April 22, 2014

Re: Florida Power & Light Company
Proposed Turkey Point Units 6 and 7
Docket Nos. 52-040 and 52-041
Supplemental Response to NRC Request for Additional Information Letter No. 72
(eRAI 6985) SRP Section 11.02 - Liquid Waste Management Systems

NRC RAI Number: 11.02-6-5 (eRAI 6985)

Figure 1 – Deep Injection Well (typical based on DIW-1EW-4)

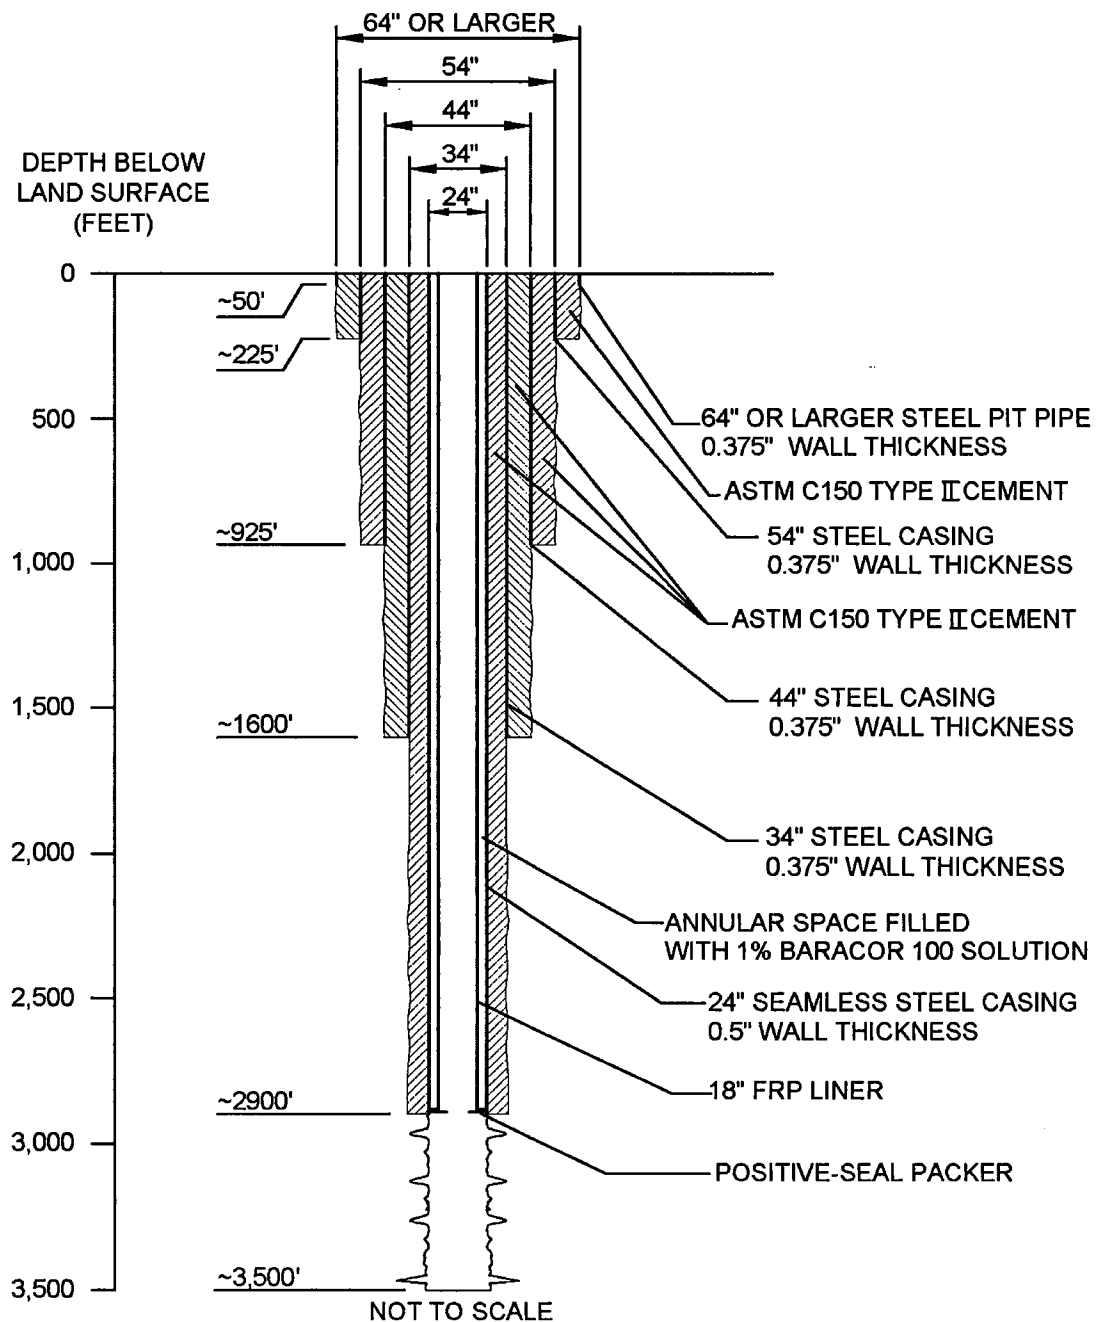
Since the deep well injection system will involve the use of 12 injection wells in relatively close proximity, the applicant is requested to address (1) a rise in pressure given the combined operation of multiple wells, and (2) potential fractures and formation of hydraulic connections, followed by upwelling into the above confining units. Regarding possible failures of well casings, the applicant is requested to describe design features of well casings and joints, and measures that will be implemented in ensuring the mechanical integrity of the injection and monitoring wells over their operational lives. In this context, the applicant is requested to describe plant operations and procedures should any upwelling or failures of the injection system be noted, and whether interim provisions will be made to use backup systems in disposing or storing of radioactive liquid effluents. The applicant should also describe well abandonment procedures, if needed during the lifetime of the license, including steps to confirm the mechanical condition of the wells, and methods and materials that would be used to plug and seal wells.

Each of the deep injection wells will be constructed with concentric steel casings to isolate and protect groundwater from injected fluid. Each injection well will be constructed with new and unused 64- (or greater), 54-, 44-, 34-, and 24-inch outside diameter steel casings designed to last for at least 60 years. The 64- (or greater), 54-, 44-, and 34-inch diameter casings will have a minimum wall thickness of 0.375-inches and conform to American Society for Testing and Material (ASTM) 139, Grade B specifications. The final 24-inch diameter casing will have a 0.5-inch wall thickness, will be seamless, and will conform to American Petroleum Institute (API) 5L specifications or ASTM 153 specifications. The well casings are selected to provide protection against casing failure during cementing operations, protect against failure during operation of the well and subsequent pressure tests, and provide sufficient corrosion protection. The 54-, 44-, and 34-inch diameter casings will be encased in cement on both the outside and the inside of the casing to protect against exposure to groundwater. The outside of the 24-inch diameter casing will be encased in cement to protect against exposure to groundwater. A nominal 18-inch diameter fiberglass reinforced plastic (FRP) injection tubing

with a wall thickness of 0.76-inches will be installed inside the 24-inch diameter casing to protect the 24-inch diameter casing from exposure to injected fluids and subsequent corrosion. The annular space between the 24-inch diameter casing and the FRP injection tubing will be filled with a non-hazardous corrosion inhibitor (e.g. one percent Baracor 100 solution) and sealed at the base and top to create a pressure-tight annular space. Thus, each steel casing is either fully encased in cement or, for the 24-inch diameter casing, the outside of the casing is encased in cement while the inside of the casing is protected by a corrosion inhibitor. Figure 1 depicts a typical deep injection well. This schematic is based on the actual subsurface conditions encountered during the installation of deep injection well DIW-1 ~~exploratory well EW-4~~.

Cement bond logging of the 24-inch diameter casing will take place after cementing all but the uppermost 200 to 400-feet of the 24-inch diameter casing in place. The purpose of performing the cement bond log prior to cementing the uppermost 200 to 400-feet of the 24-inch diameter casing is to allow the cement bond logging tool to be calibrated to uncemented casing prior to performing the log.

The cement bond log will be performed from the base of the 24-inch diameter casing to land surface and will be used to identify the presence of poor cement bonding with casing and/or formation. The uppermost 200 to 400-feet of the 24-inch diameter casing will then be cemented to land surface. Following completion of cementing the 24-inch diameter casing of each deep injection well in place, the casing will undergo a video inspection by lowering a submersible video camera down the inside of the casing to verify the absence of features that could potentially negatively impact the mechanical integrity of the well. The 24-inch diameter casing will also undergo pressure testing at a minimum pressure of 150 psi prior to installation of the nominal 18-inch diameter FRP injection tubing. The 24-inch diameter casing pressure test will be performed by increasing the pressure to a minimum pressure of 150 psi and monitoring the annular pressure for a period of one-hour. A pressure fluctuation of less than five percent at the end of the one-hour test is required for the pressure test to successfully demonstrate a lack of leaks in the 24-inch diameter casing.
